Exhibit 4

Sierra Club's April 9, 2015 Comments ("SC Comments") and Exhibits 1 – 12 submitted with SC Comments.

RE: Ocotillo Power Plant – Permit Number V95-007

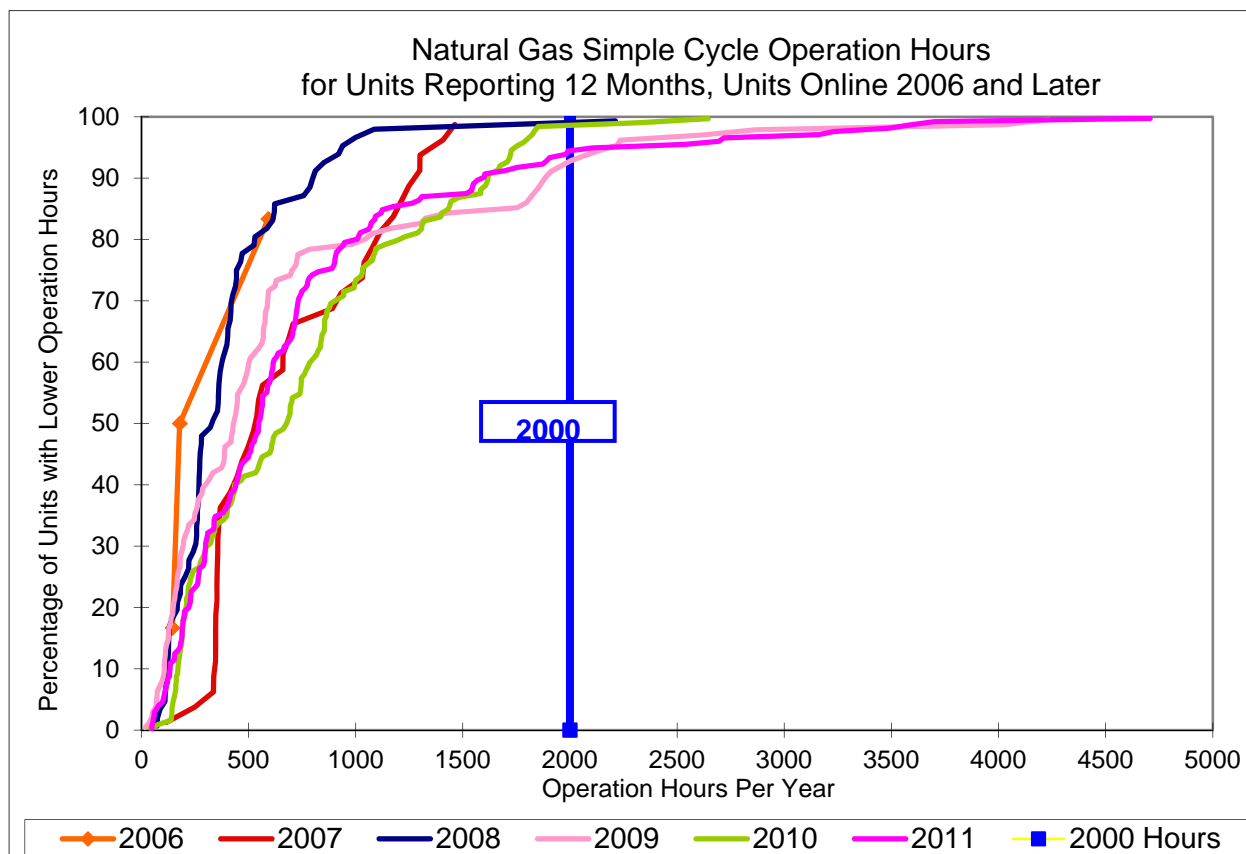
The assumed number of hours of operation can be back calculated from the emissions by dividing the tons per year per turbine by the pounds per hour per turbine. (Ap., Tables 3-1, 3-2.) This calculation for the major pollutants yields an average of 3,571 hr/yr of normal operation per turbine.⁵⁸ (Ap., Table 3-1.) In addition, each turbine would undergo up to 730 startups/shutdowns per year, each lasting a total of 41 minutes (30 min startup, 11 min shutdown). (Ap. Table 3-2.) This amounts to 499 hours per year per turbine⁵⁹ of startup and shutdown. Thus, each turbine is permitted to operate 4,070 hr/yr or 46% of the time.

The Applicant’s proposed operation of the Ocotillo plant deviates substantially from the historical operation of “peaking units.” The annual operating hours for the proposed Ocotillo turbines are much higher than typical peaking units. The available data show that almost all simple cycle turbines have low operating hours. In contrast, the emission calculations for Ocotillo show that each LMS100 turbine would operate approximately 4,070 hrs/yr. Figure 1 shows this level of planned operation is far too high to be considered a “peaker.” The “knee in the curve” in the table below shows that more than 90% of existing simple-cycle units operated at 2,000 hours or less for 2011 (the most favorable⁶⁰ year for industry), thus showing that operation greater than 2,000 hours is not consistent with the normal operation of combustion turbines in peaking service.
